Resource Planning Advisory Group feedback report

Meeting details

- Thursday, May 28, 2026, 1:00 p.m. - 3:30 p.m.
- Virtual webinar hosted by PSE and facilitated by Maul Foster & Alongi
- Links to:
 - [Presentation](#)
 - [Agenda](#)
 - [Meeting recording](#)

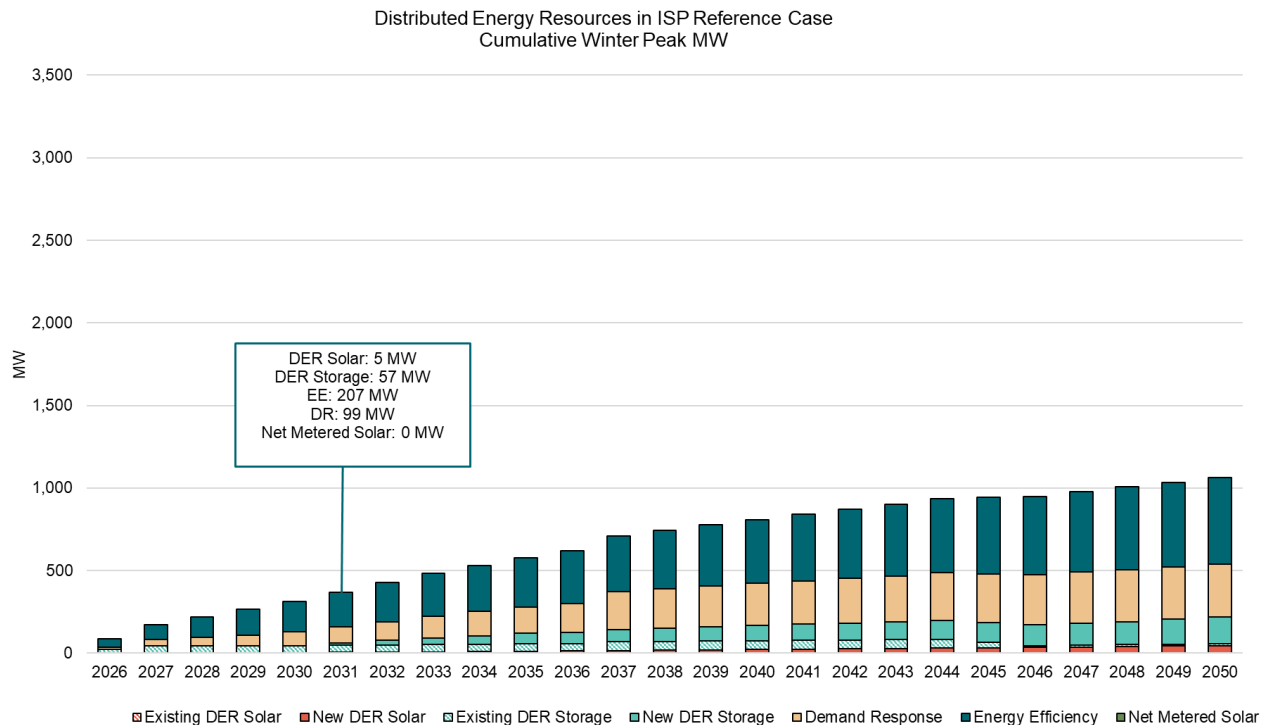
1. Could we see the effective load carrying capability (ELCC) version of the chart on slide 18?

Here is the updated chart:
